# Memo

**To:** Patricia Davis, P.E., Brad Marshall  
**From:** Jonathan Tran, P.E., Ron Mick, P.E.  
**Copy:** Matt Gaughan, P.E., Charles Cameron  
**Date:** November 12, 2021  
**Subject:** CWWTP1 Change Order 0005

For the Central Wastewater Treatment Plant Expansion project, the Owner's Representative Team recommends approval of the attached Change Order 0005 in the amount of \$125,009.25 and 113 additional days to the contract with BAR Constructors, Inc. as indicated in Table 1 below.

**RE: S-EB-2 Electrical Building No. 1 Framing and CMU Wall Layout Plans**

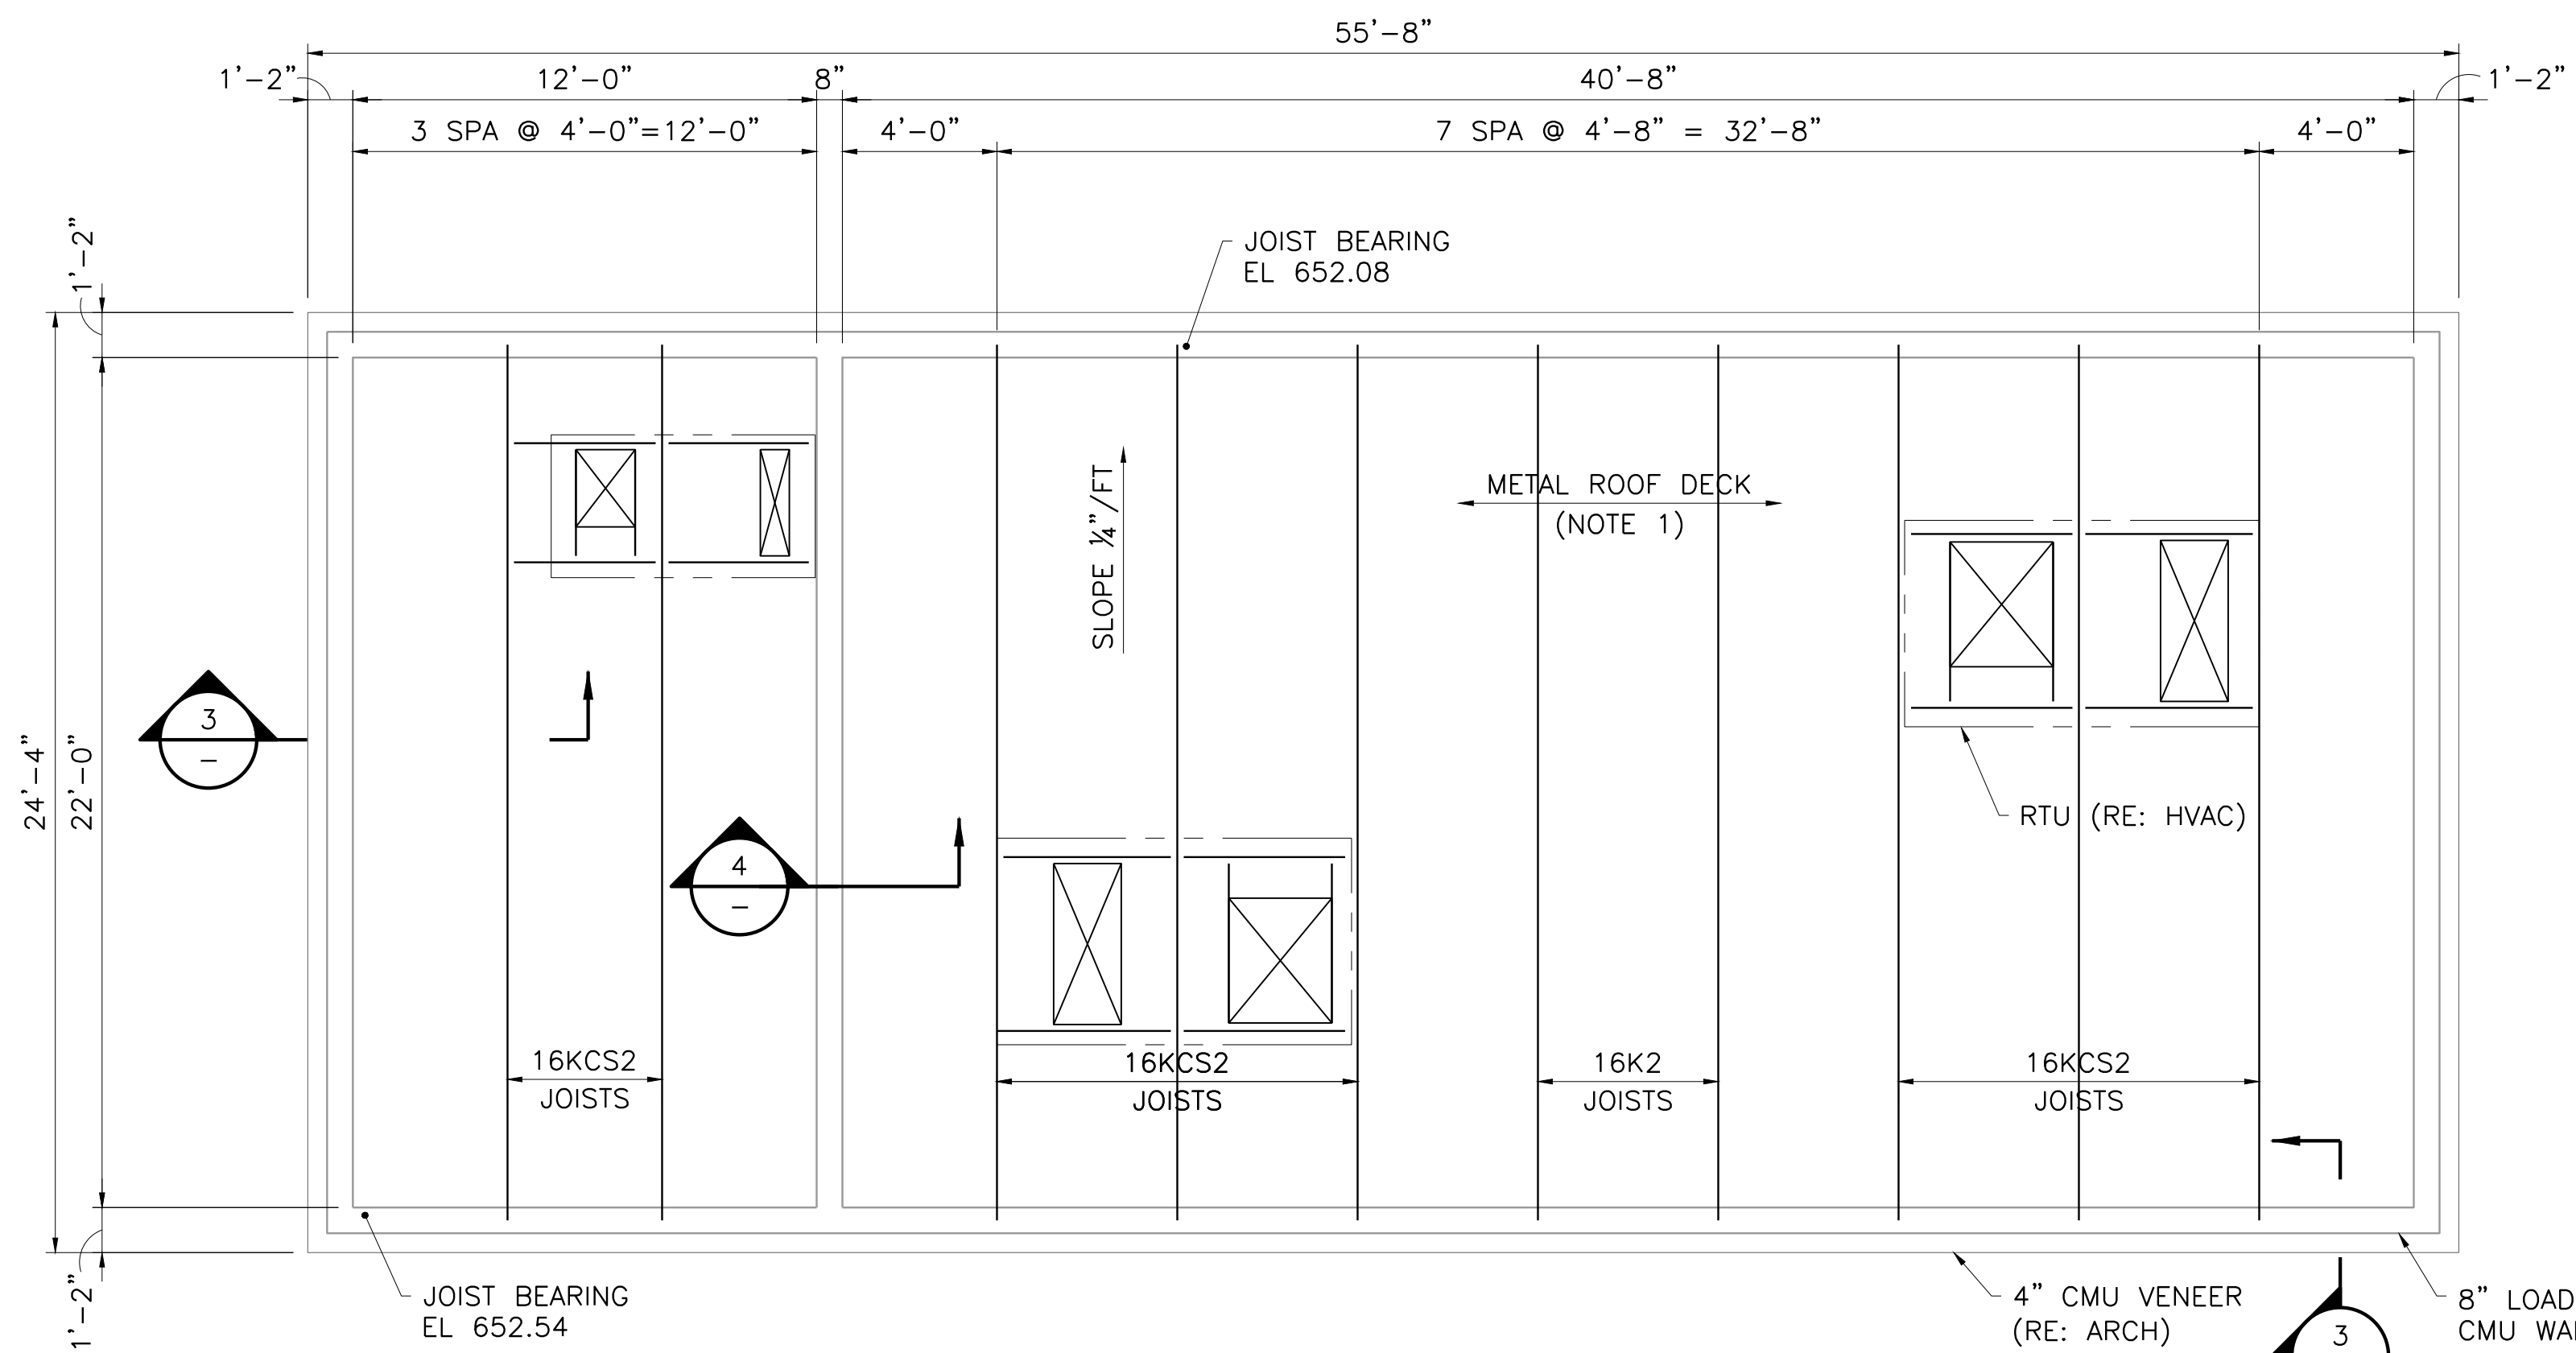
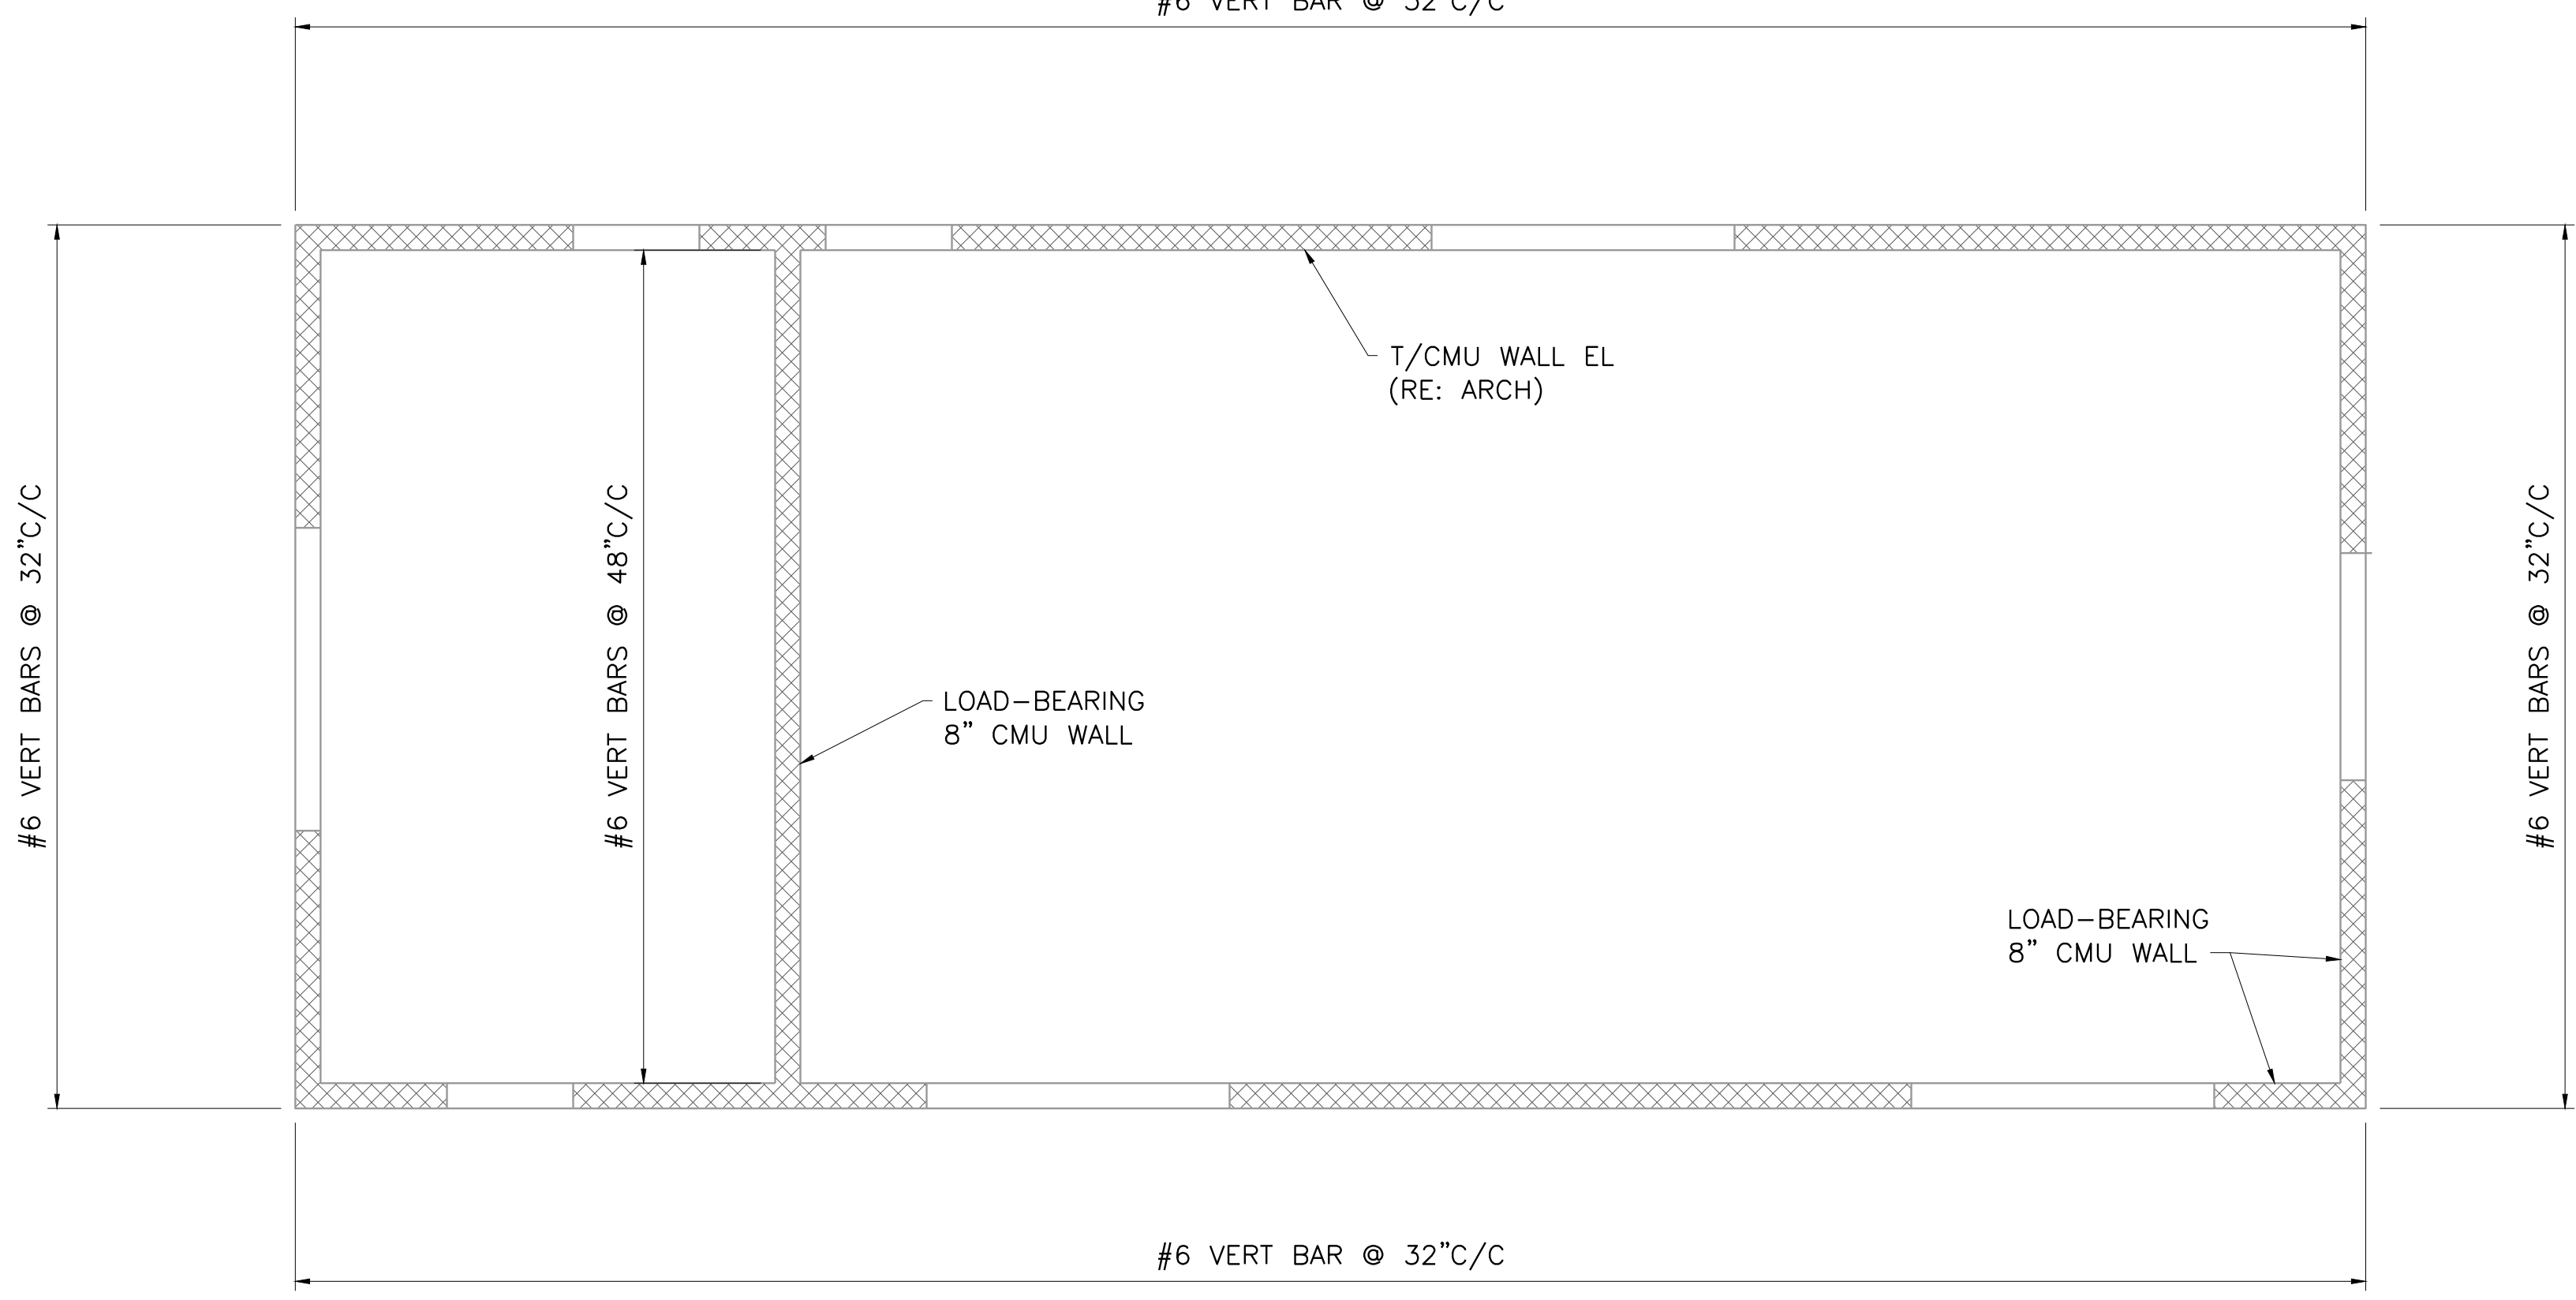
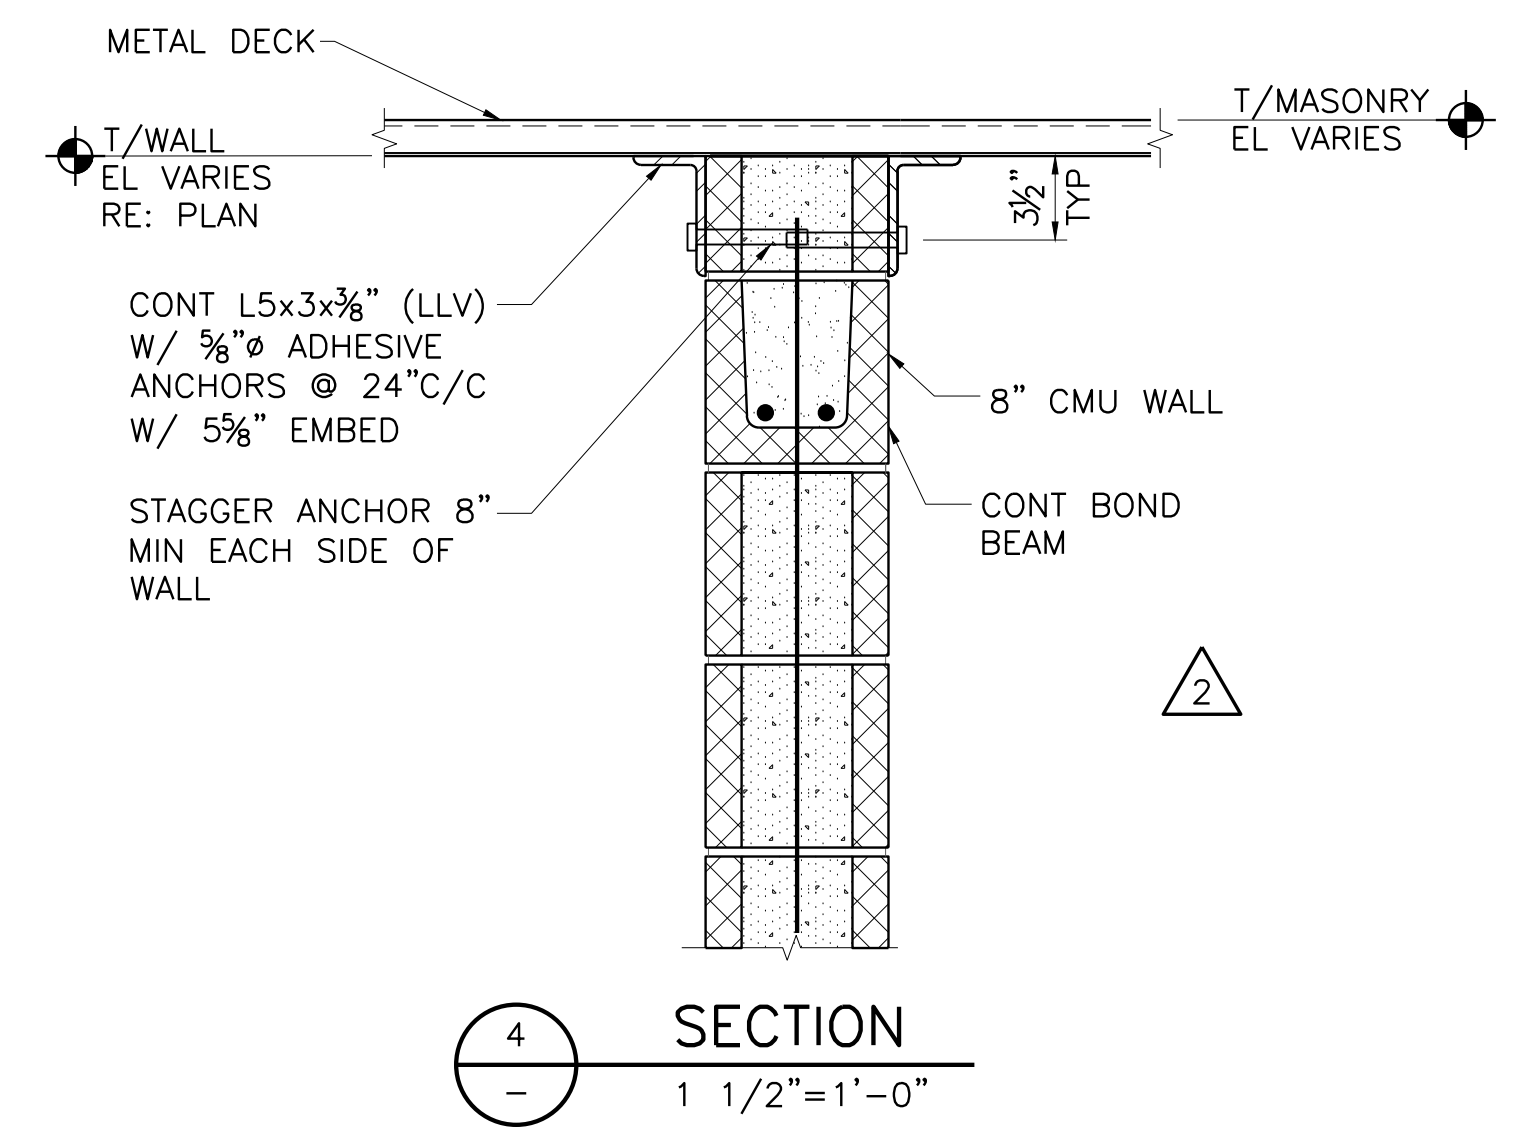
Replace sheet **S-EB-2 Electrical Building No. 1 Framing and CMU Wall Layout Plans** with the revised version attached to this field order. The modification to this sheet clarifies the means of attaching the roof ladders to the side of the electrical buildings via anchoring into the 8" CMU wall.

<b>Purpose of Change Proposal:</b>			
The Structural Engineer issued a revised ladder anchor attachment detail on 6/29/21 that provides a more structurally secure ladder. Revision to the ladder at EB-3 will be required and additional hardware will be required at EB-1 and 2.			
<b>Attachments:</b>			
<b>Requested Action:</b>			
<input type="checkbox"/> Issue a Field Order <input checked="" type="checkbox"/> Issue a Work Change Directive or Change Order for the described changes			
<b>Basis of Compensation:</b>			
<input type="checkbox"/> Unit Prices <input checked="" type="checkbox"/> Lump Sum calculated using Cost of Work provisions in General Conditions Paragraph 13.01 <input type="checkbox"/> Time and Materials using Cost of Work provisions in General Conditions Paragraph 13.01			
<b>Required Documentation:</b>			
<input checked="" type="checkbox"/> Detailed cost breakdown attached showing labor, materials, equipment, and all other costs for this change <input type="checkbox"/> Schedule attached to show impacts and justification for requested change in Contract Times
